HISTORIC AND DESIGN REVIEW COMMISSION

February 20, 2019

HDRC CASE NO: 2018-623
ADDRESS: 119 E KINGS HWY
LEGAL DESCRIPTION: NCB 3257 BLK 1 LOT 8&9
ZONING: R-5,H
CITY COUNCIL DIST.: 1
DISTRICT: Monte Vista Historic District
APPLICANT: Troy Jessee
OWNER: Scott and Cassandra Leune
TYPE OF WORK: Rear accessory structure modifications
APPLICATION RECEIVED: January 28, 2019
60-DAY REVIEW: March 29, 2019
REQUEST:

1. Remove the front canopy element from the rear accessory structure.
2. Replace the rear accessory carriage doors in-kind.

1911 - 1924 SANBORN MAP

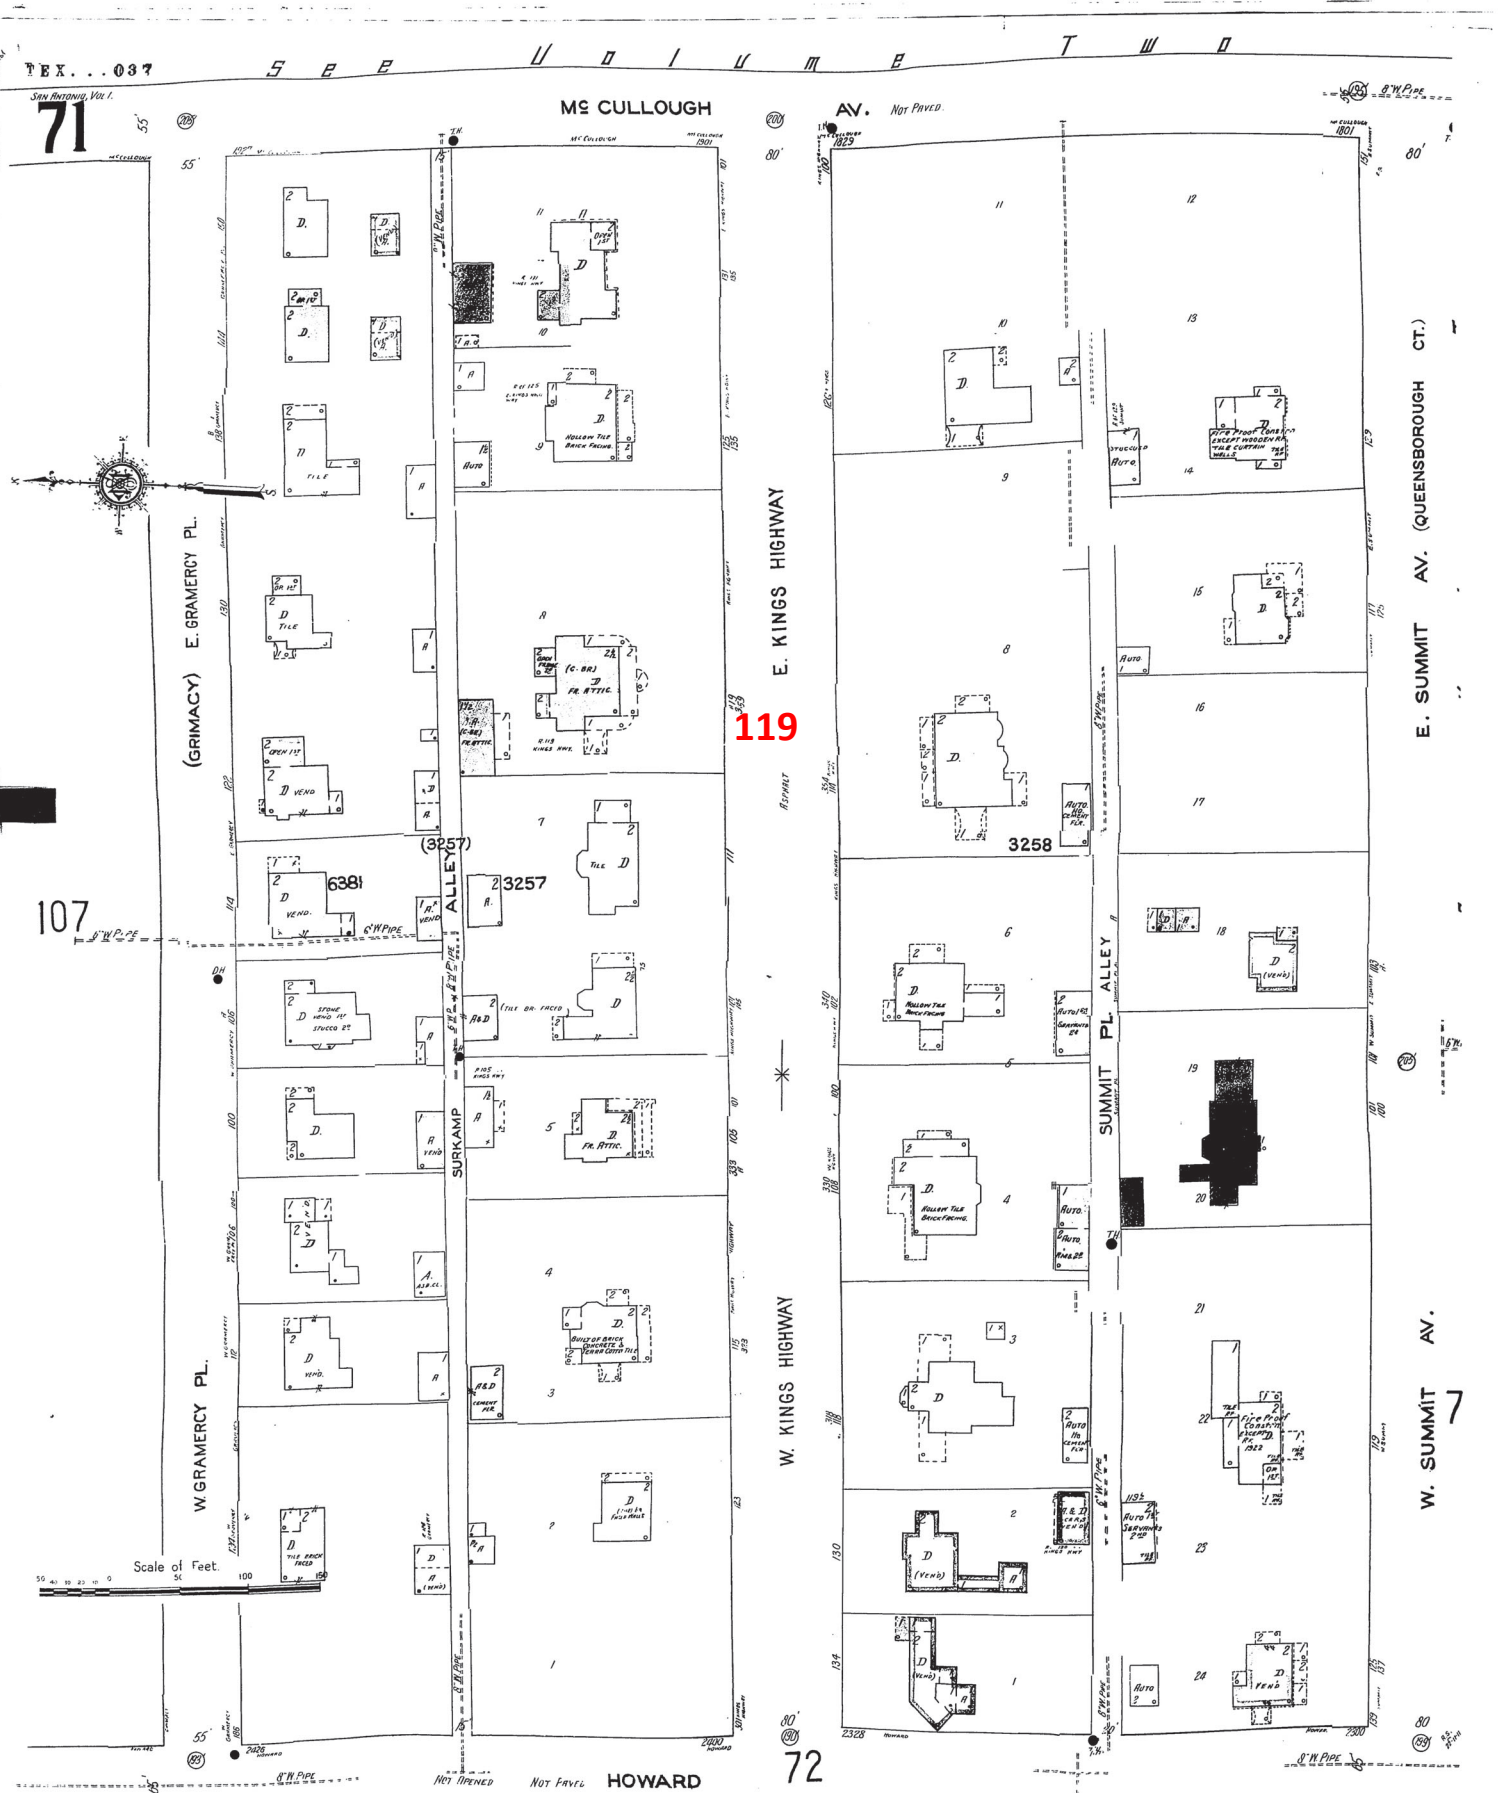
Existing awning view
from sidewalk. Two
columns are visible
and 2D profile of
fascia.

Columns do not match
fluted profile of any
other column on home.
Column bases are
plastered and painted

Soffit is rotting

This roof line is most likely not original to existing carriage house. It obstructs the original profile of the house that could be visible from the street. We will extend the existing cedar shake siding and trim profile continuously.

Columns block turning radius of vehicles from garage and limits access and turning radius to carport beyond. Will set limestone caps into pavers to indicate locations of columns.

Awning has
frankensteiner gutter /
downspout system that
is NOT original. This
will be cleaned up with
continuous profile.

Awning has frankenstein gutter / downspout system that is NOT original. This will be cleaned up with new proposed awning.

Existing
Conditions

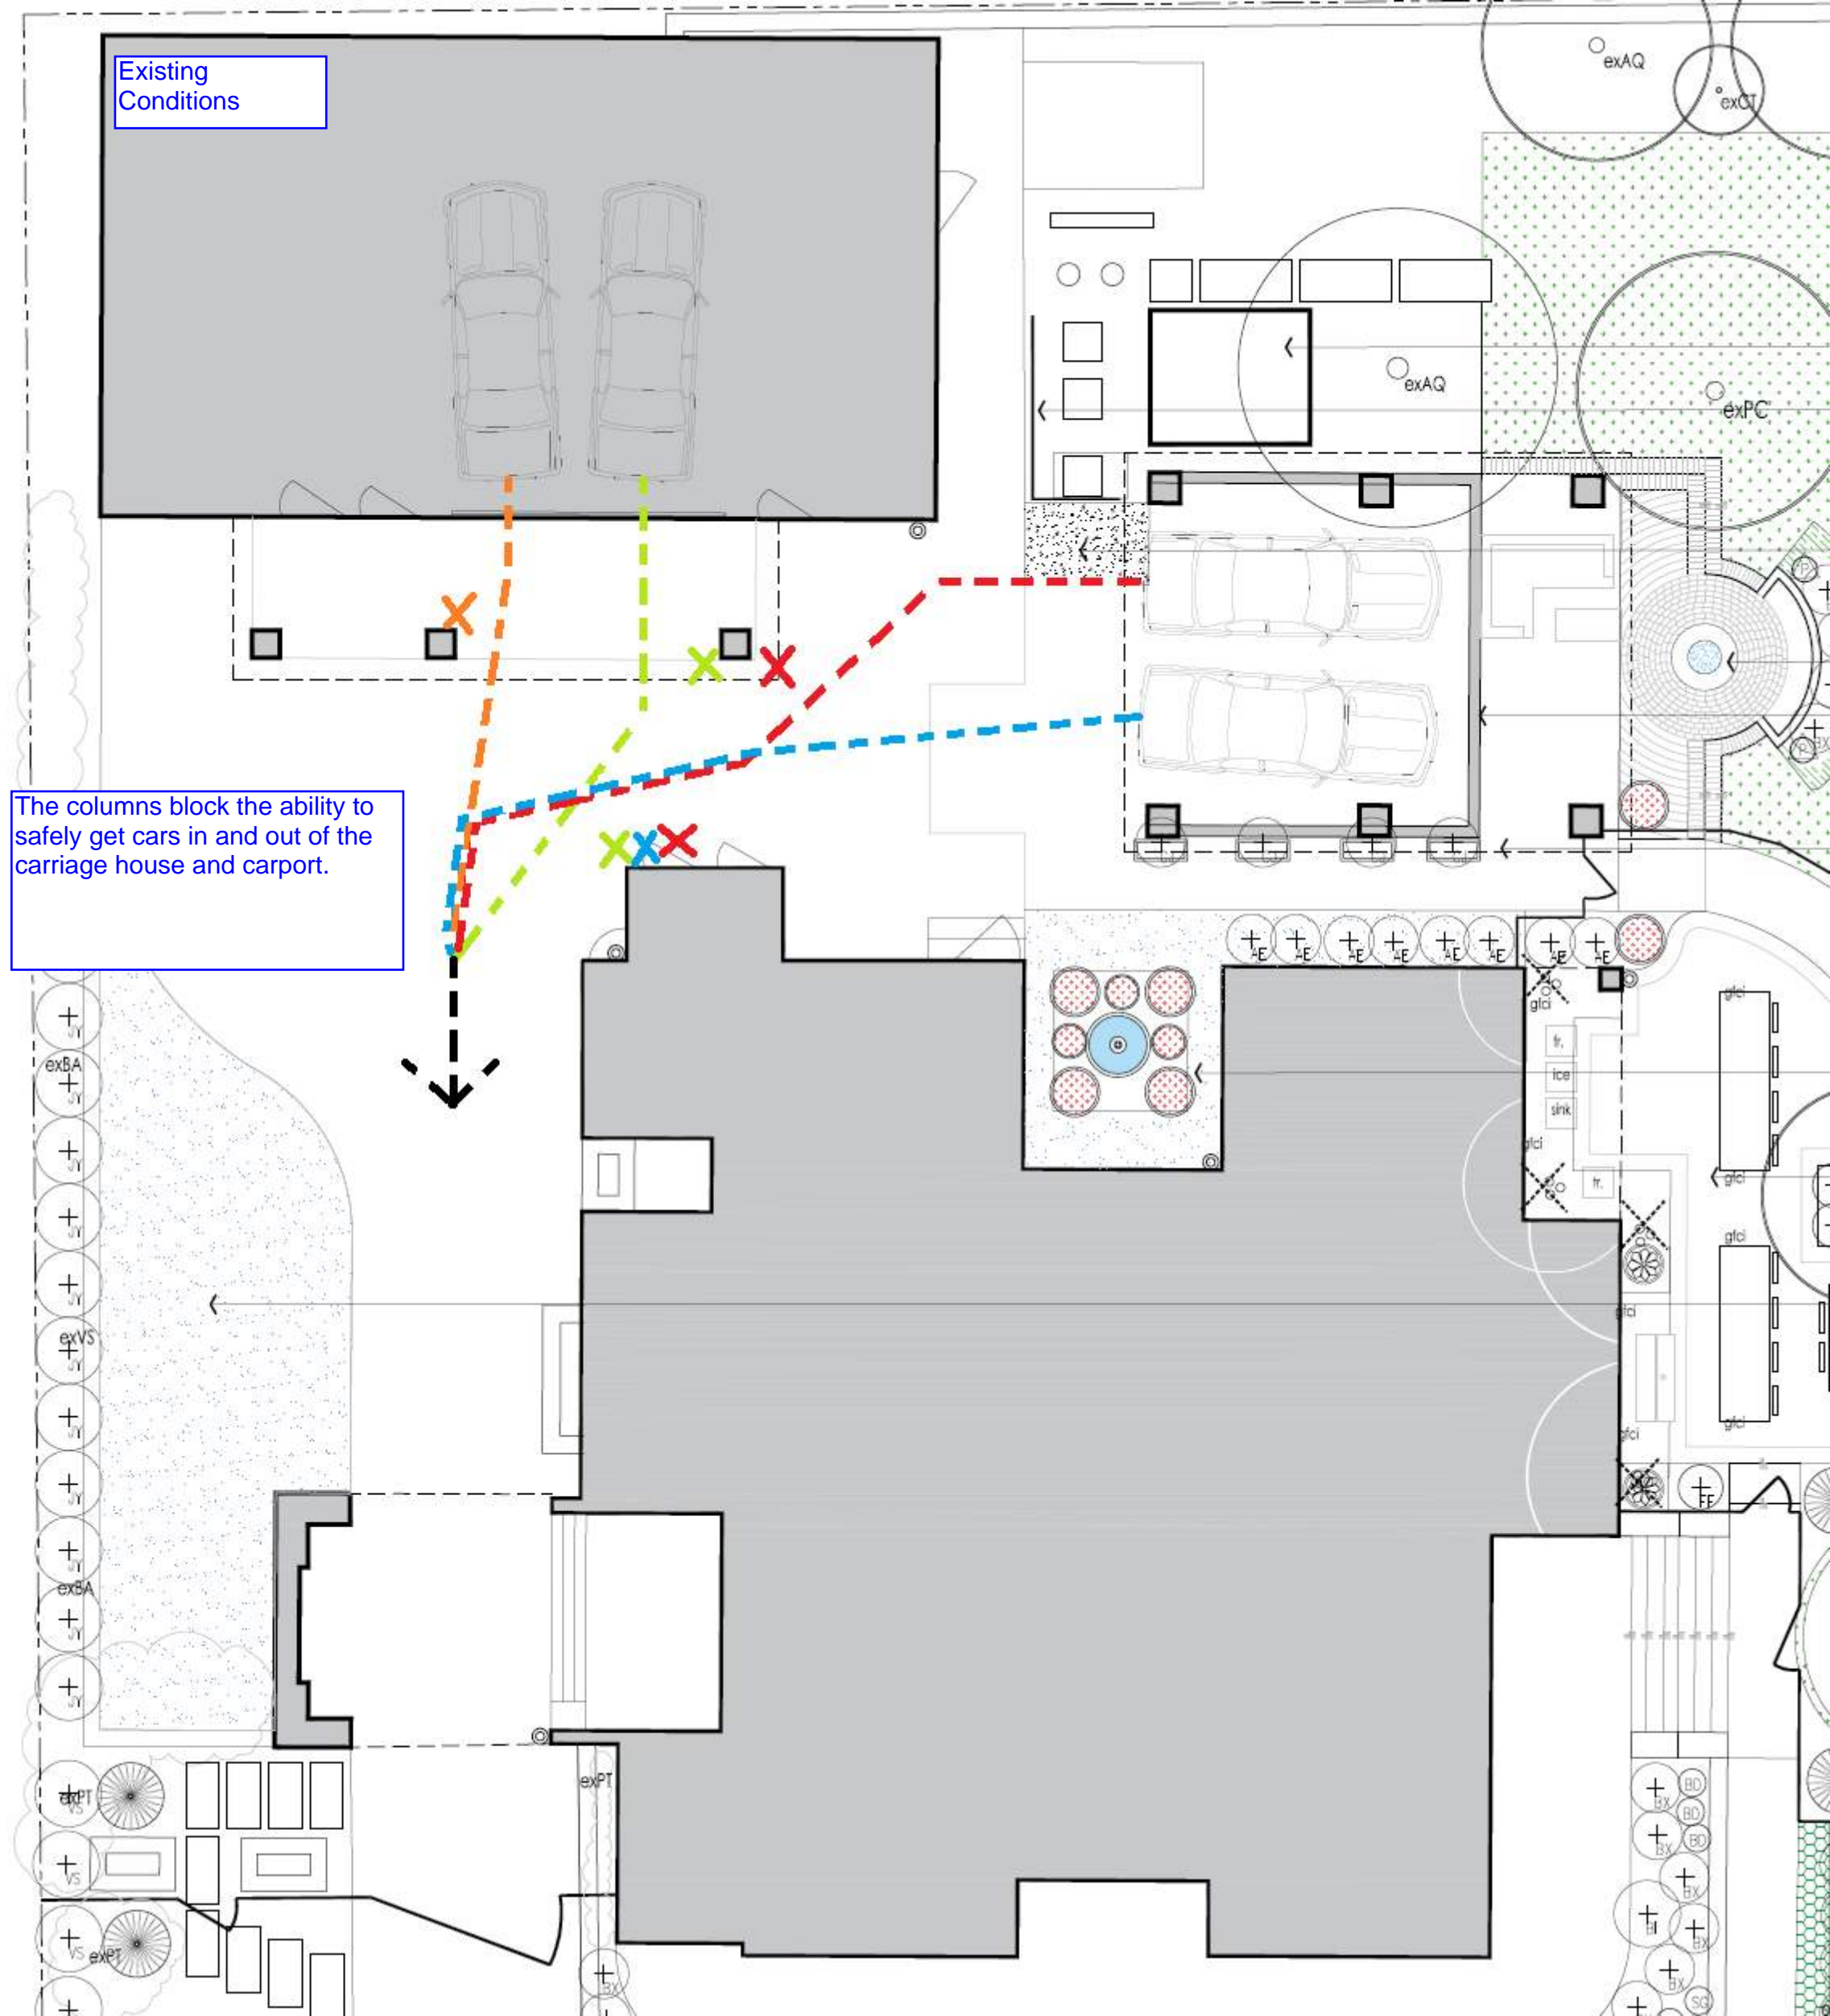
Column bases are beat up and plastered.

The distance between the column and the existing main house make the turning radius extremely difficult to turn without clipping the column.

The columns block the ability to safely get cars in and out of the carriage house and carport.

Proposed Plan

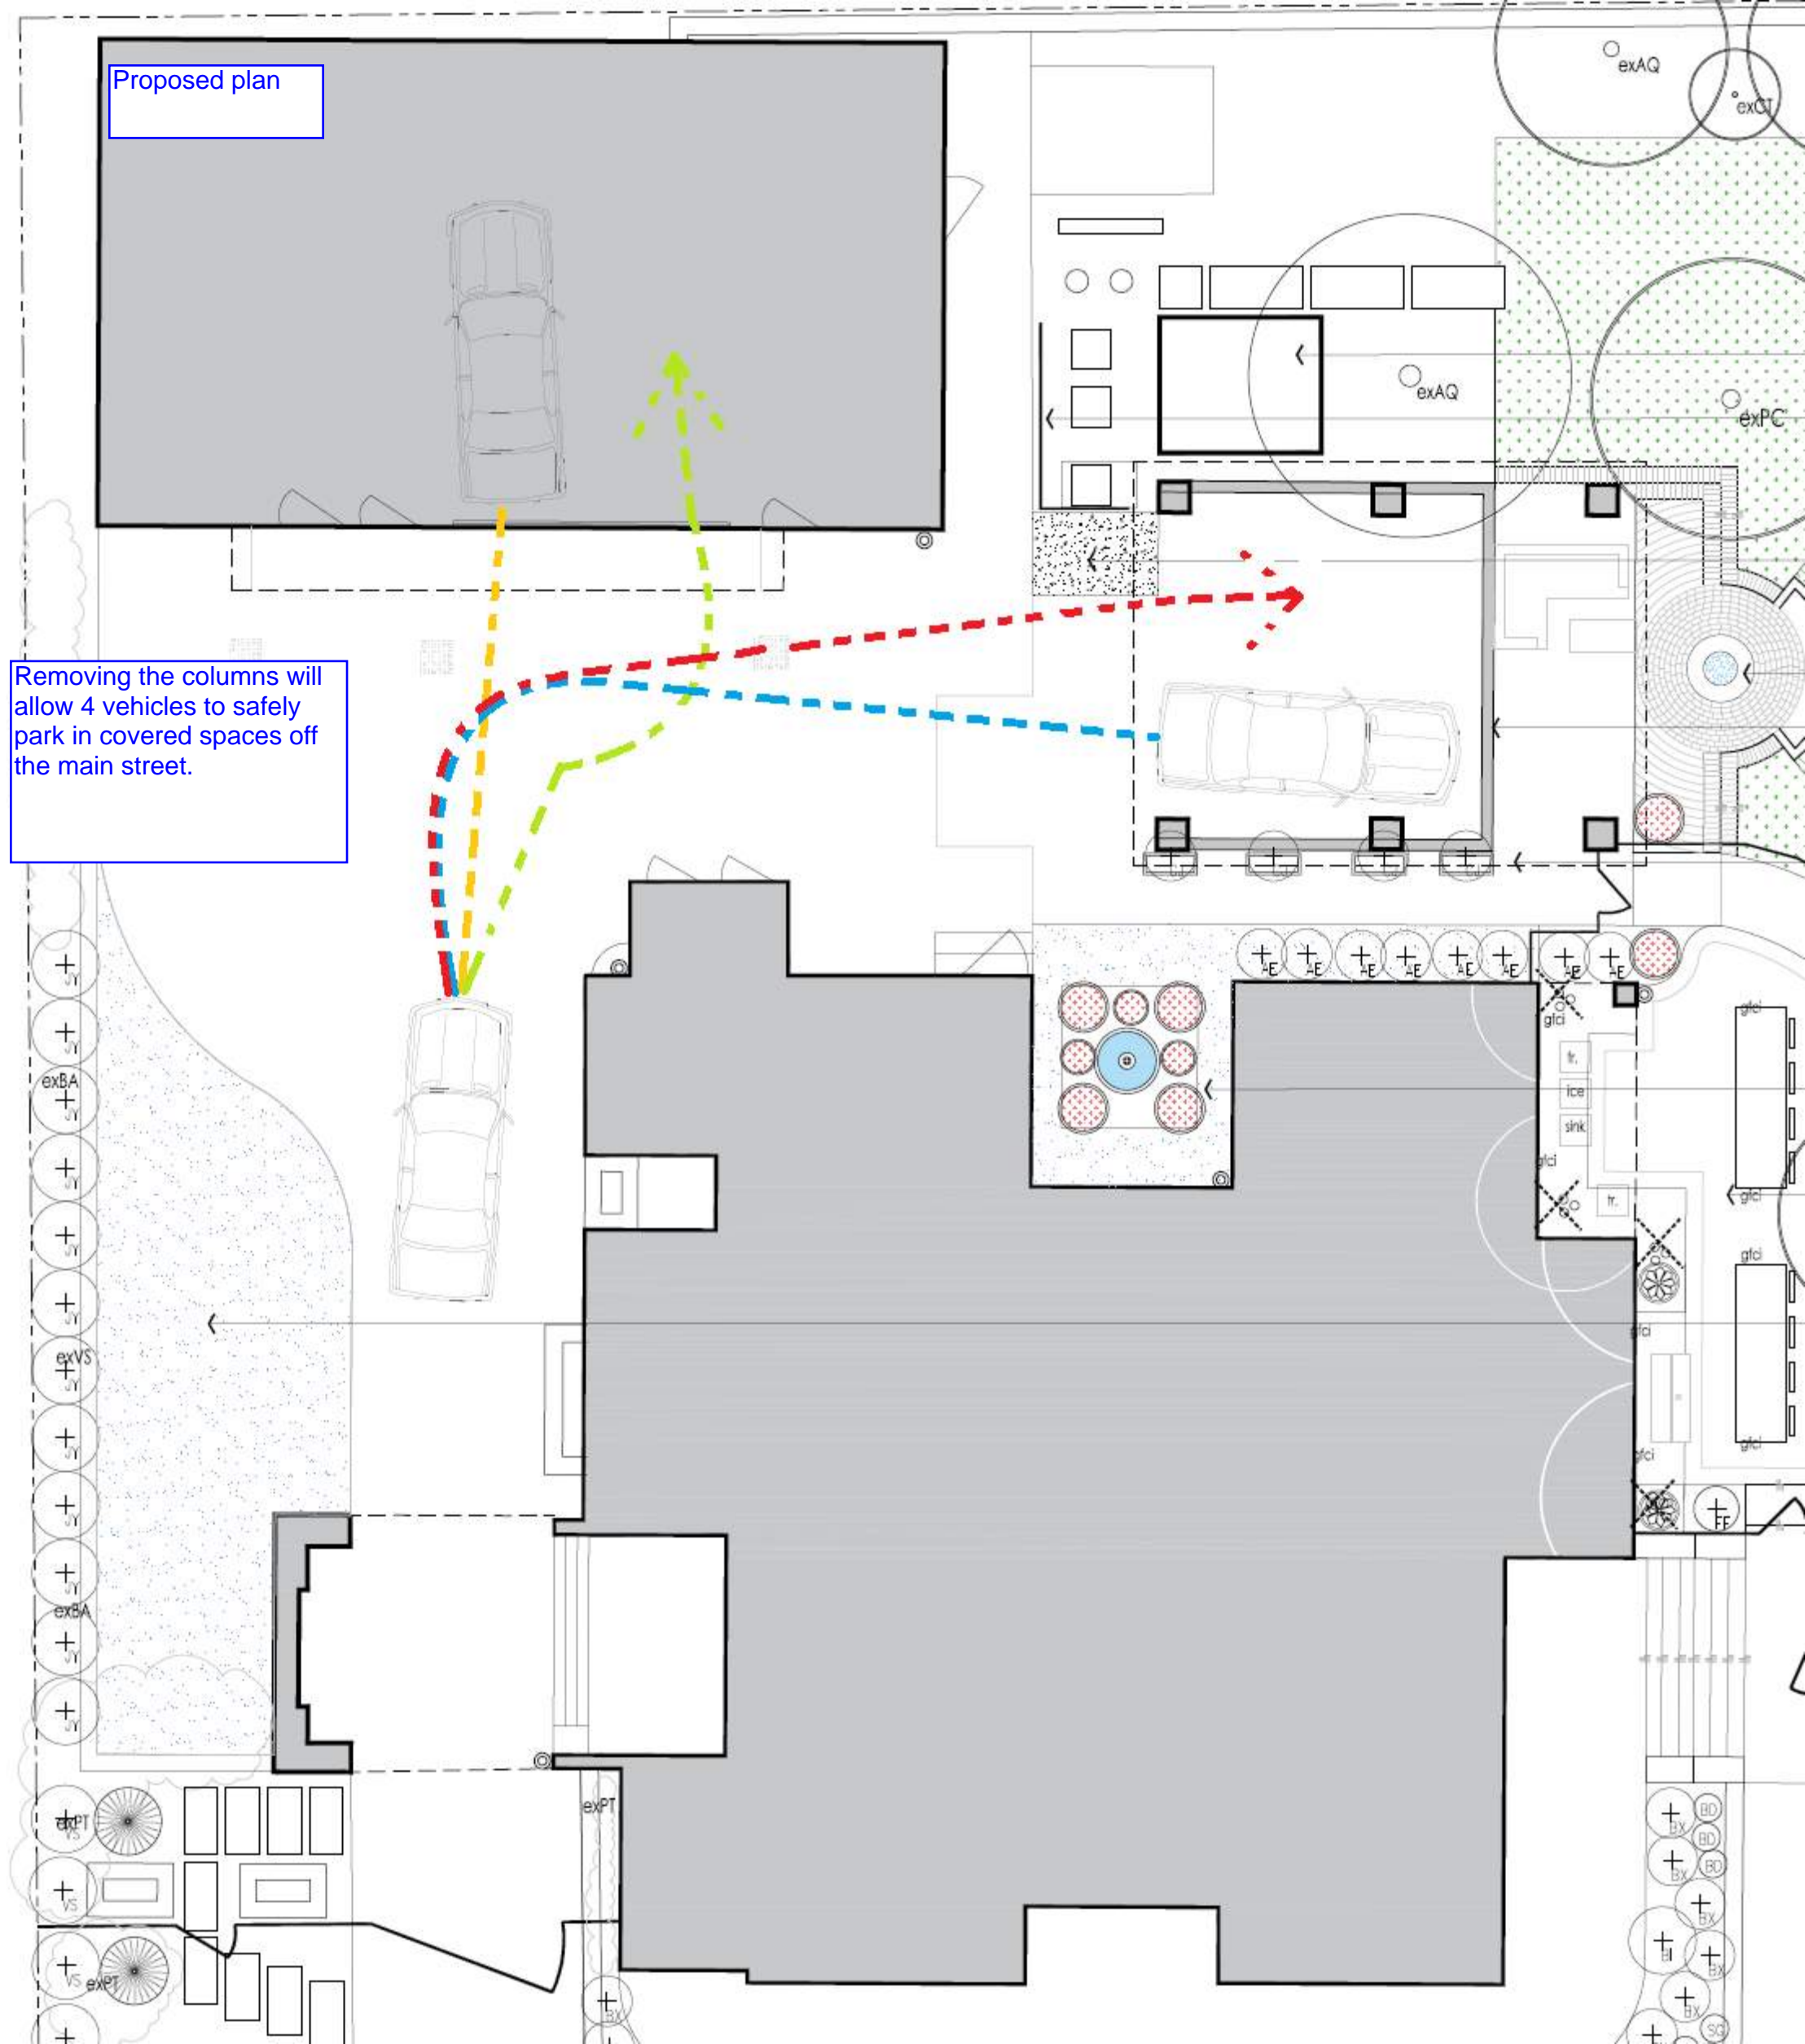
Removing the columns will allow 4 vehicles to safely park in covered spaces off the main street.

Removing the columns will allow 4 vehicles to safely park in covered spaces off the main street.
